Service Bulletin

SUBJECT: Service Update for Inventory Vehicles Only
Transmission Gear Whine Noise
Expires April 30, 2016

MODELS: 2015 Cadillac Escalade, Escalade ESV
2015 Chevrolet Silverado LD Crew, Silverado LD Crew LTZ,
Silverado LD Ext LTZ
2015 GMC Sierra LD Crew, Sierra LD Crew Denali, Sierra LD Ext,
Yukon, Yukon Denali, Yukon XL, Yukon XL Denali
Equipped with 8-Speed Transmission (M5U) and 6.2L Engine (L86)

Subject: 15178A – Service Update Bulletin
Transmission Gear Noise

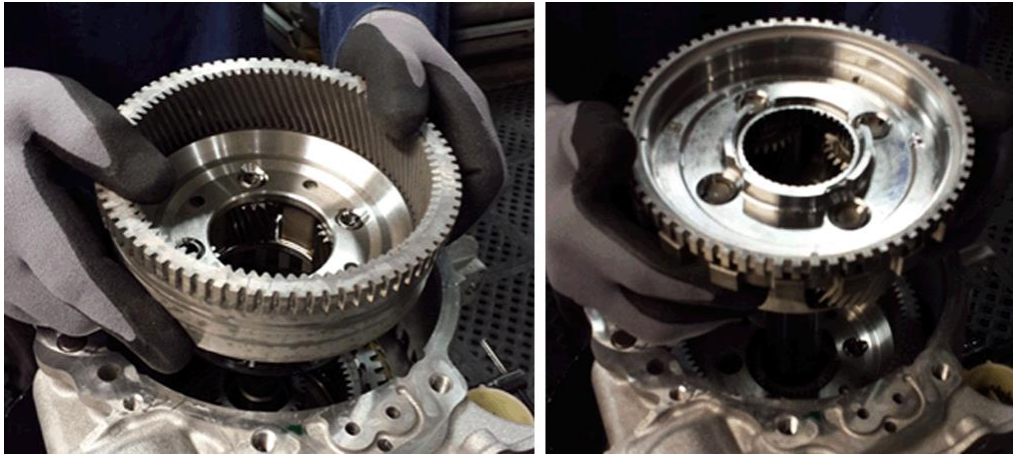
The Parts Information, Service Procedure and Warranty Transaction Information sections have been revised. Part numbers 11546930 and 11612187 have been removed. Repair steps 15, 16 and 17 have been modified. Floor plan reimbursement instructions have been added. Please discard all copies of bulletin 15178.

15. Remove the reaction carrier assembly.

4121120

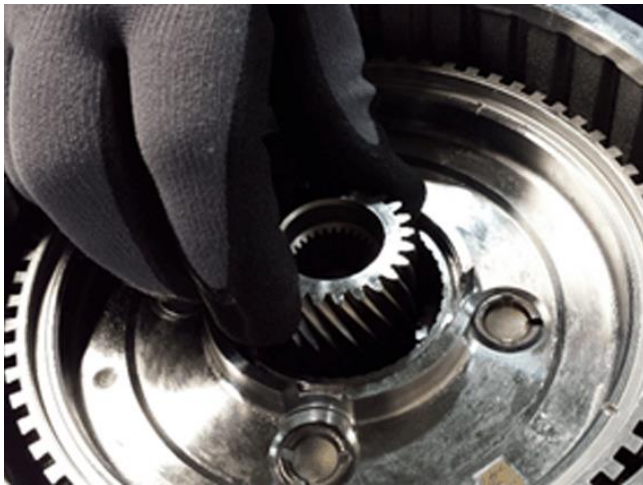
16. Install the new reaction carrier assembly.

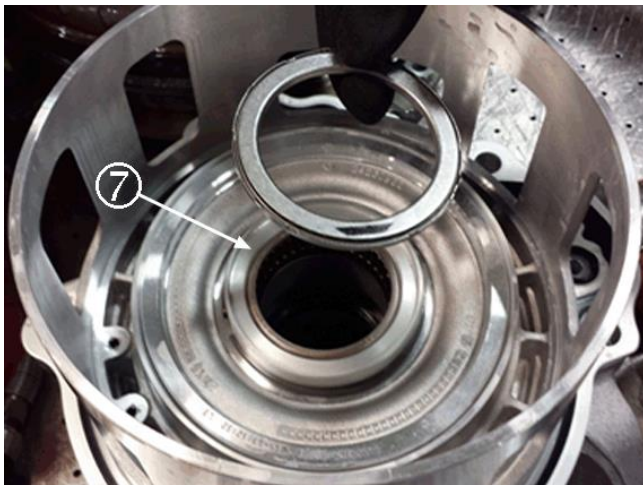
17. Install the old output carrier assembly.
